30th July 2021

**Statement of Environmental Effects
Modification of Development Consent DA2011/0360
Alterations and additions to an existing residential flat building
48a Queenscliff Road, Queenscliff**

Figure 2 - Stamped plan extract DA2011/0360 showing location of the terraced landscaping and access stairs which are being deleted as a component of this application. These stairs would have required

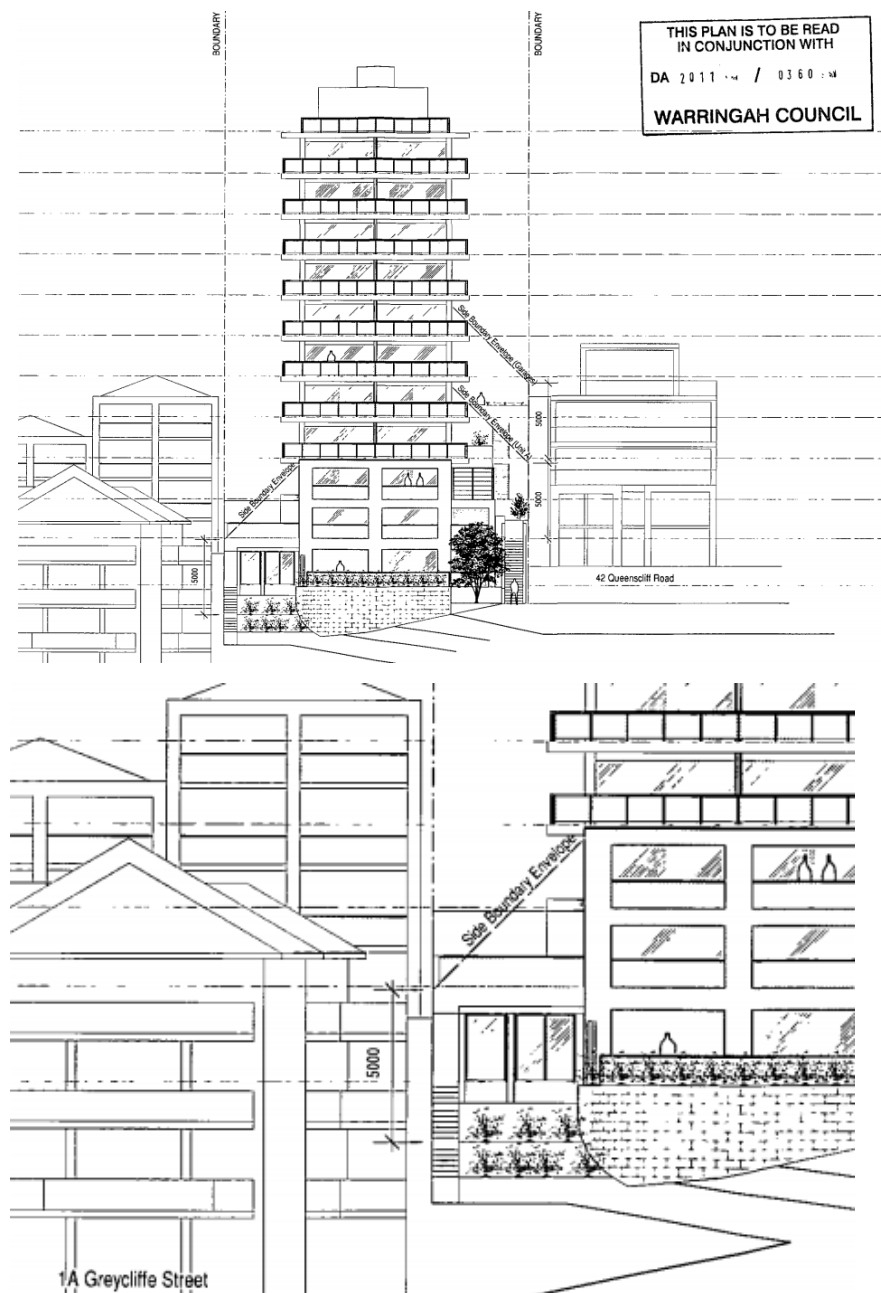
- The modified landscape design will not give rise to any inappropriate or jarring visual impacts as viewed from any adjoining residential property or the adjacent public domain. In fact, the removal of the approved access pathway, which would have required a 1 metre high balustrade along its length, would have resulted in significantly greater visual impacts as viewed from the lower level apartment within the adjoining development to the west No. 1A Greycliffe Street as depicted in Figure 2 over page.

a 1 metre high balustrade, or a dividing fence, to prevent persons falling into the adjoining property/ comply with the BCA
